Board of Adjustment Hearing Application - Entry #297

7 Kingspointe Lake Ct.
Clarkson Valley, MO
63005
US

Re: Building Permit Application - 7 Kingspointe Lake Ct

To: Chairman & Members of the Board of Adjustment
From: Paul Mercurio, Building Commissioner
cc: Sue McNamara, Mayor
Date: June 26, 2026
Re: Board of Adjustment Variance Request – 7 Kingspointe Lake Ct.

P_EIFER: P_LAN VIEW

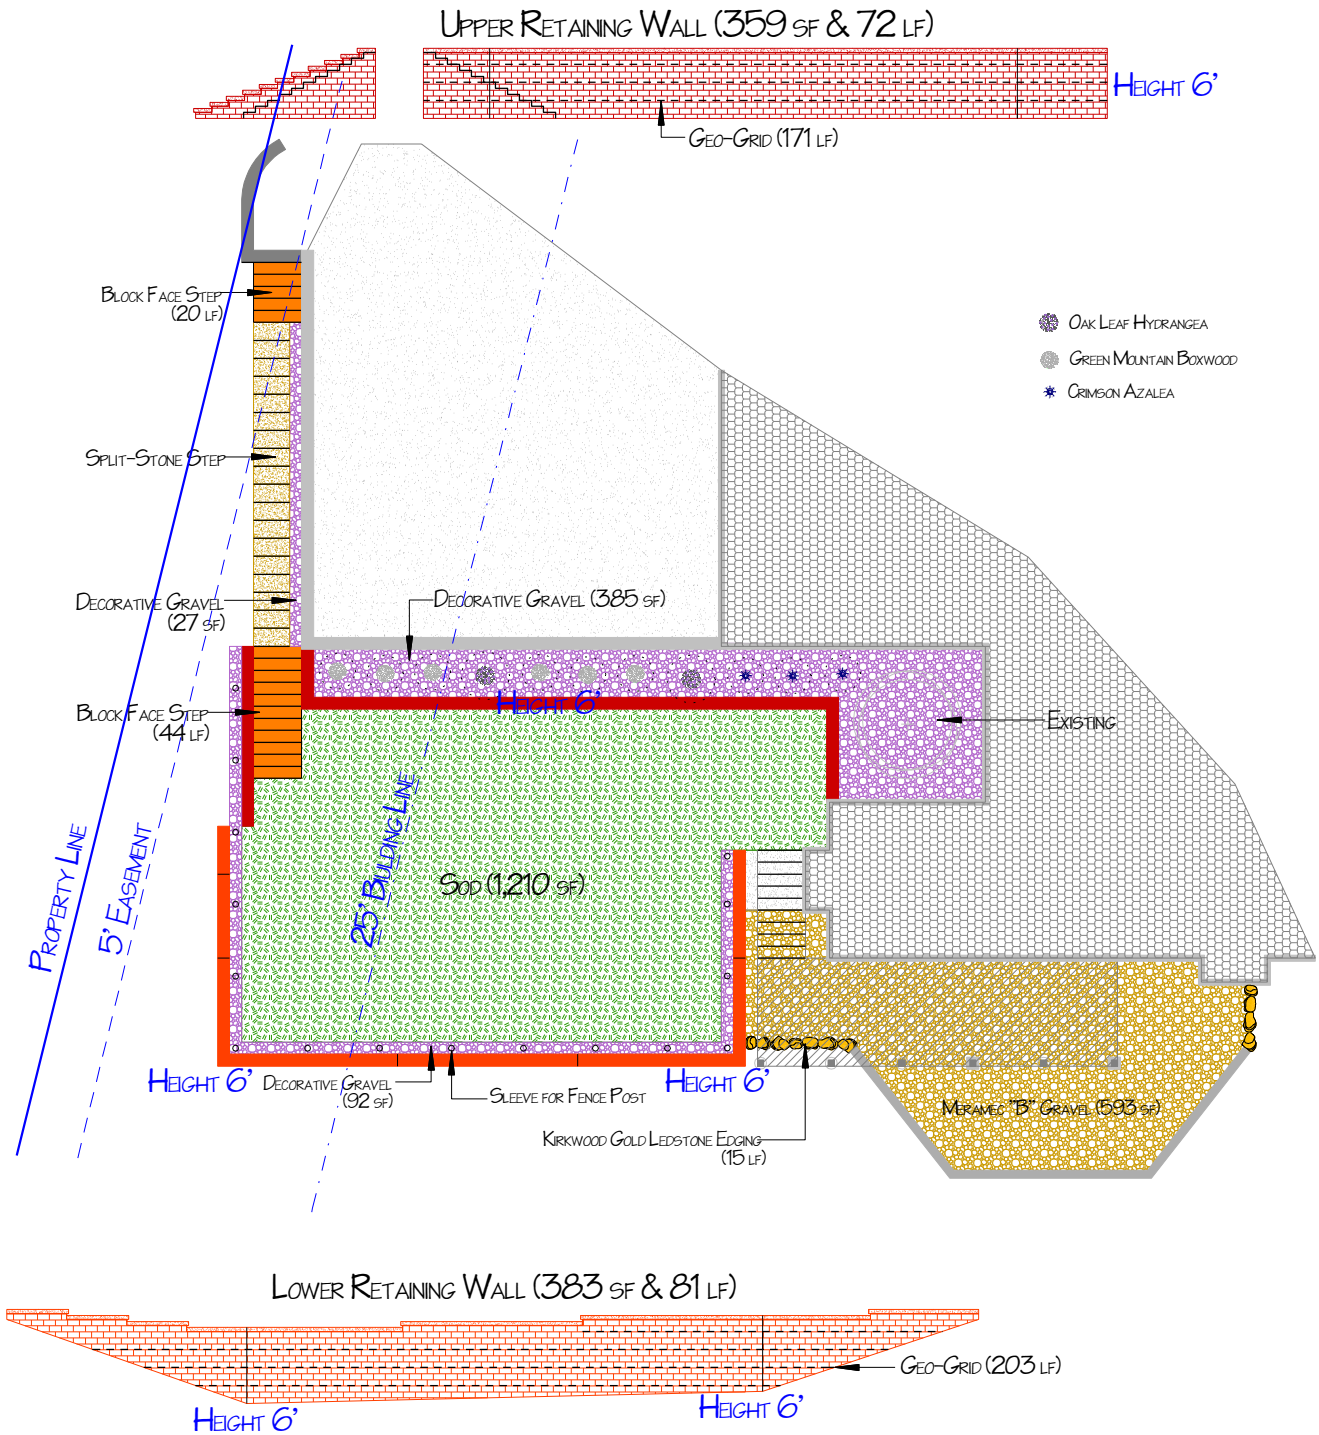
1. The plan notes sleeves for fence posts. Is a fence proposed as part of this project? If so, please provide the related details.
2. Please provide the height of each retaining wall and show these dimensions clearly on the plans.
3. The steps must include a handrail. Please provide details for a code-compliant handrail and elevations showing the surrounding topography so I can determine whether a guardrail is also required along the steps.
4. It appears both walls extend into the south 25-foot building line setback, which does not comply with zoning requirements. Please provide the exact wall dimensions in this area. If either wall height is more than 24 inches and into the 25-foot setback, I cannot approve the building permit without a variance from the Clarkson Valley Board of Adjustment. Please contact Clarkson Valley staff for information about that process.
